RE: Wellington Prep Plant(C/007/0012): Change of Operations

Title: Change of Operations

Wellington Preparation Plant (C/007/0012)
Mining & Reclamation Plan
Changes & Insertion Instructions
November 15, 2013

The following are proposed changes to the Wellington Preparation Plant permit along with instructions for insertion to the existing Mining & Reclamation Plan (MRP). This amendment is the **Redline/Strikeout** version of the document.

Mt. Nebo Scientific, Inc.
 Springville, UT **Dwg. 712K**

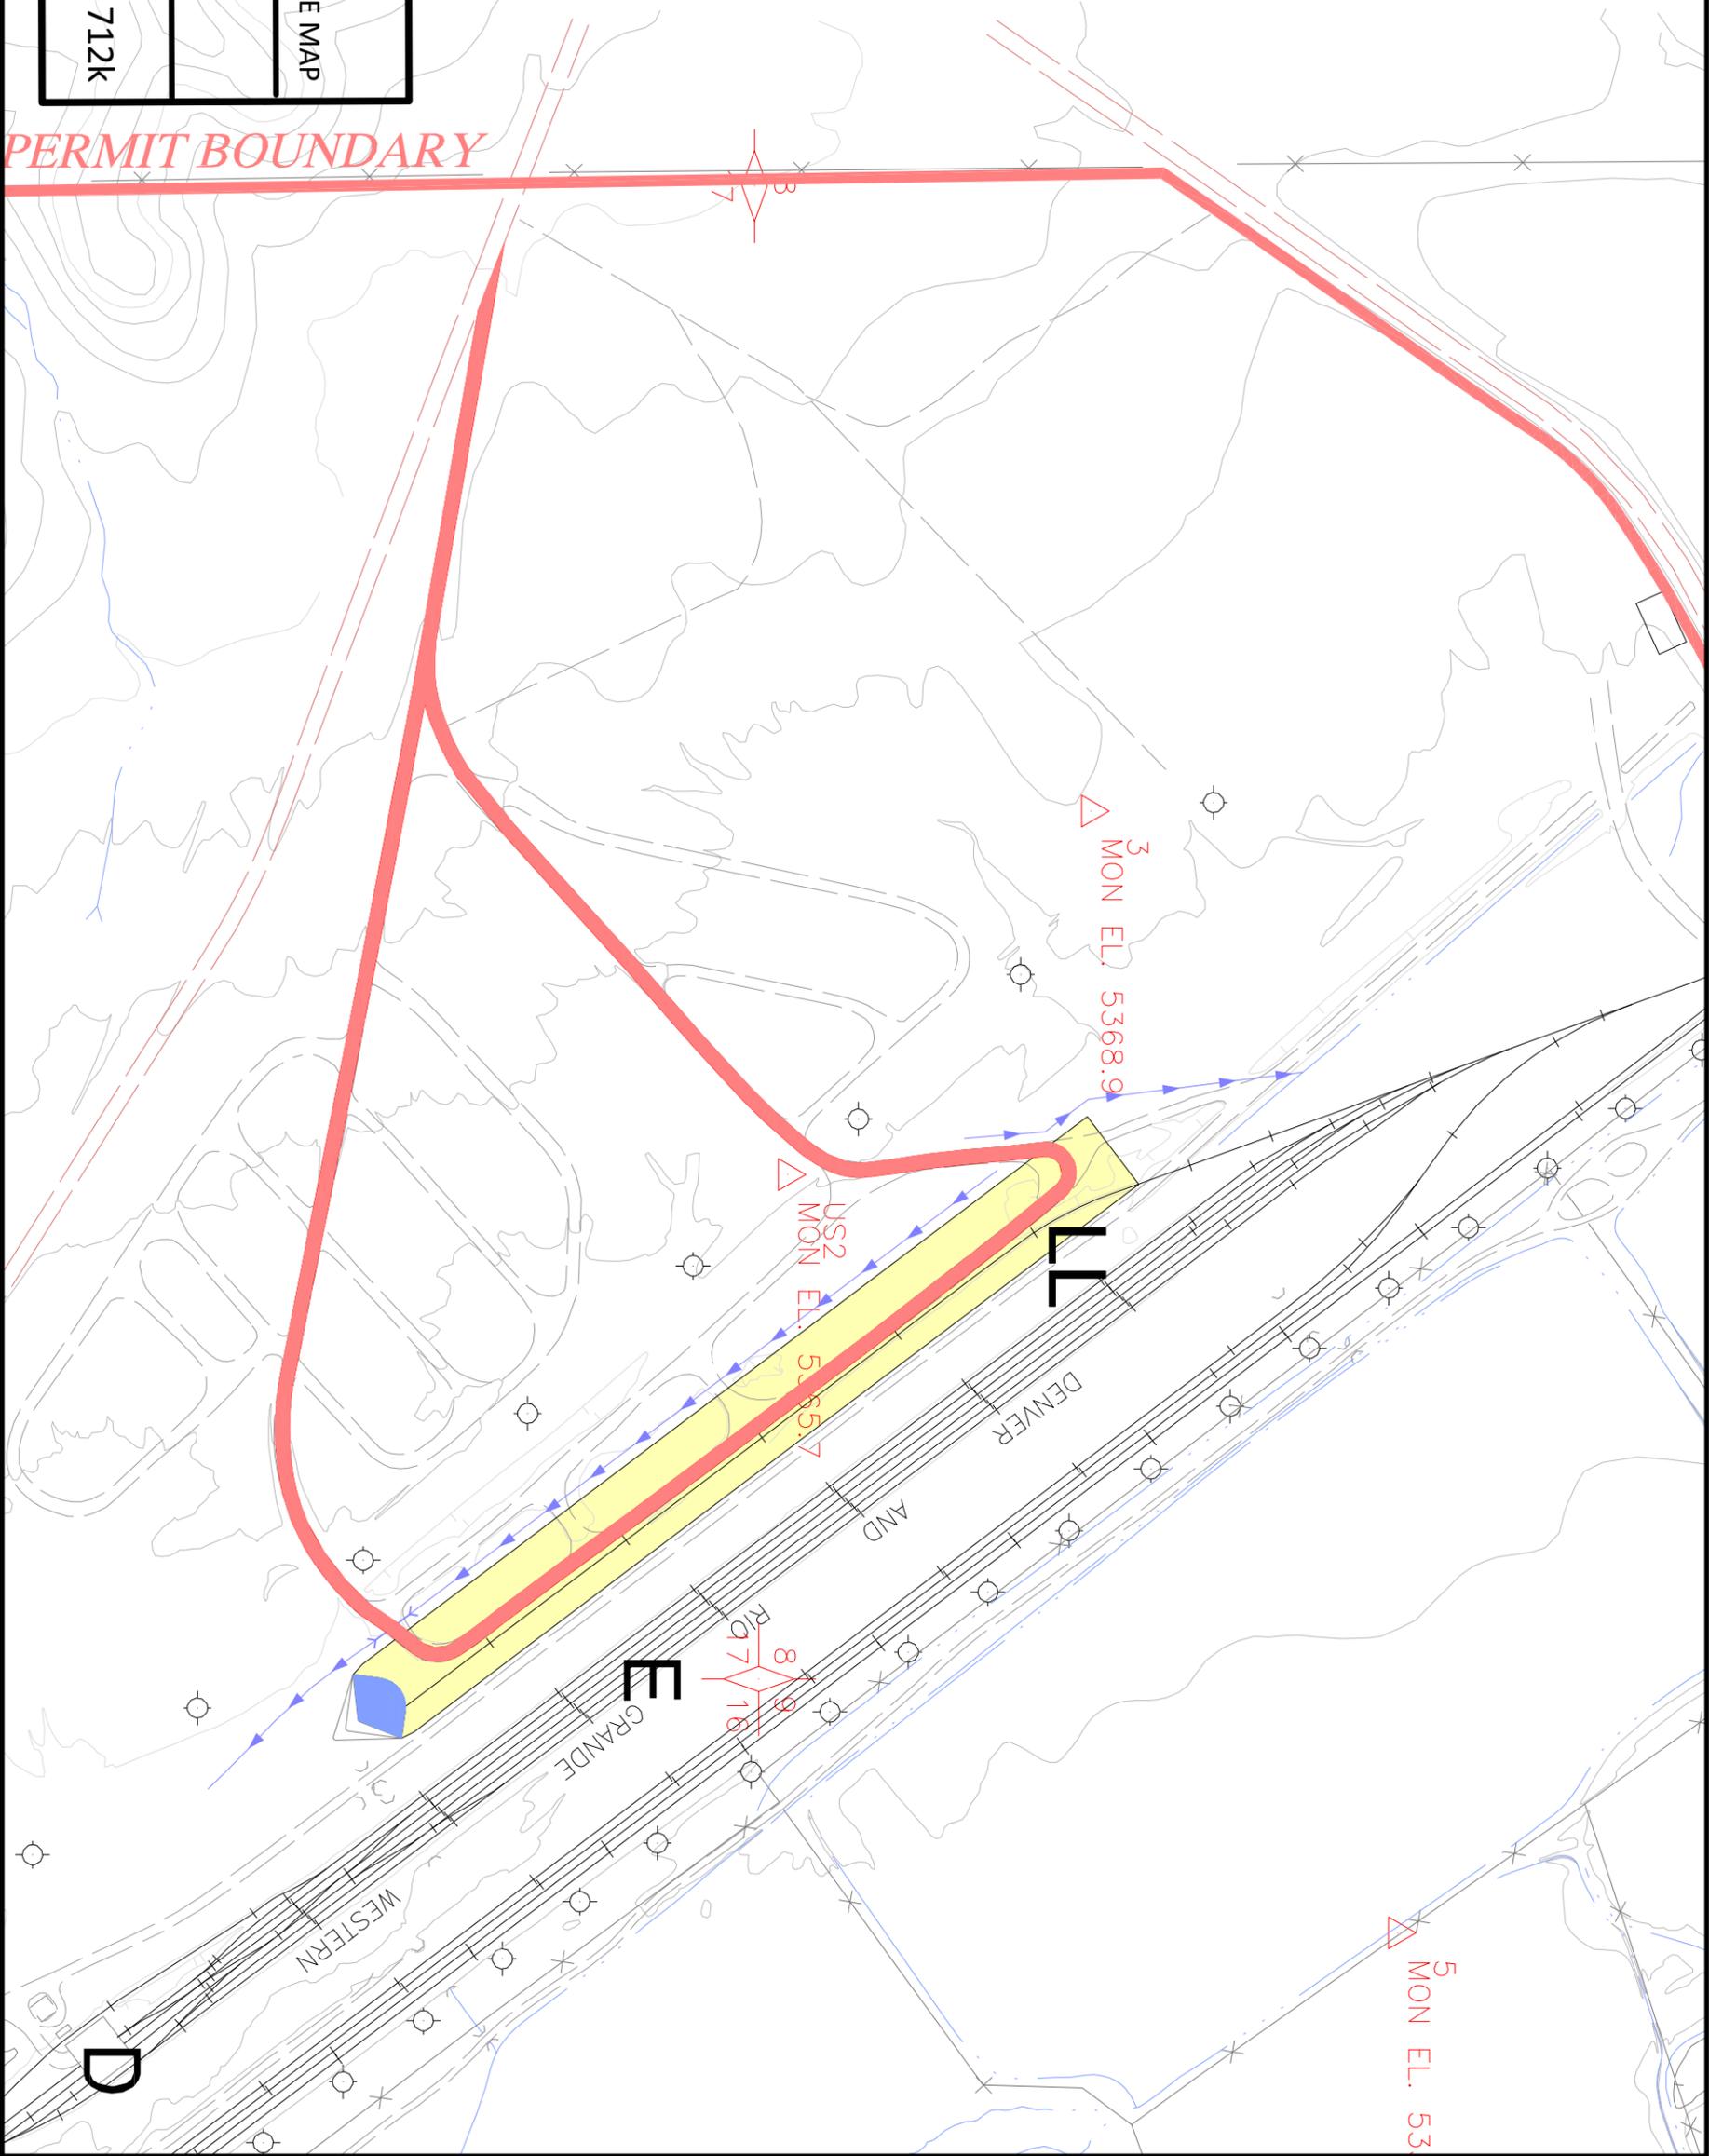
- Dwg 712k, Transloading Catchment Basin Site Map, 11/8/13 of this submittal should be added to the Division's copy of the MRP.
